Buttons

TITLE: GTA04b7

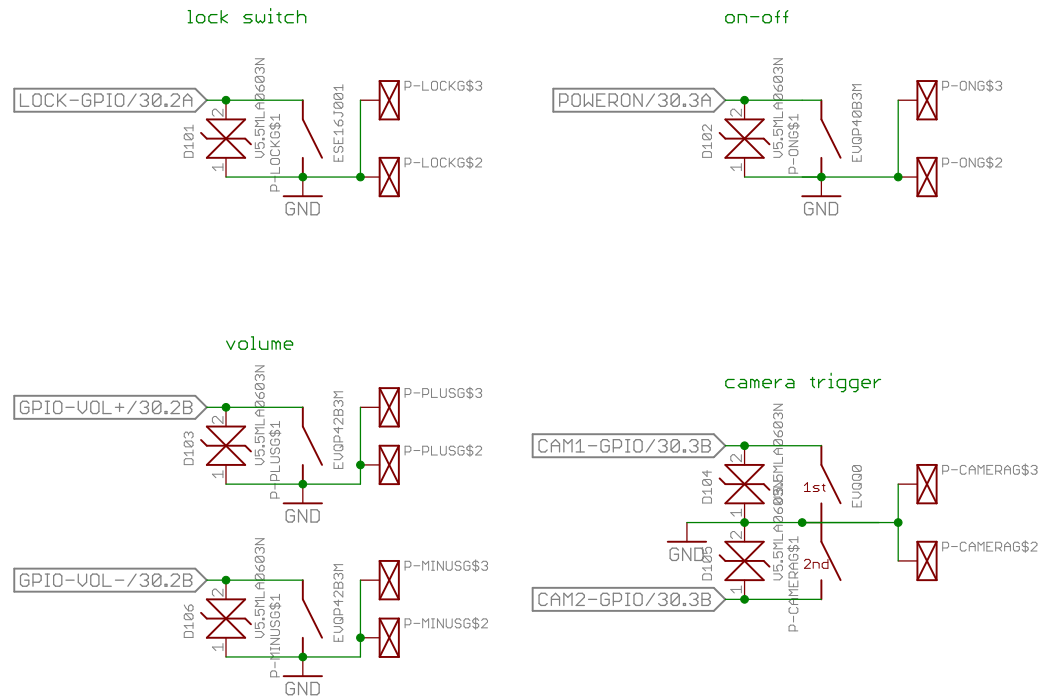
Ok for V2b

place in scan matrix? would need 3-4 wires to UPPER board instead of 2!
No. UOL+ or UOL- can either be connected to GPIOs
or drive two FETs that sit in the keyboard matrix
in any case it is sufficient to connect GPIO-UOL+ and UOL- to two pins on the B2B connector
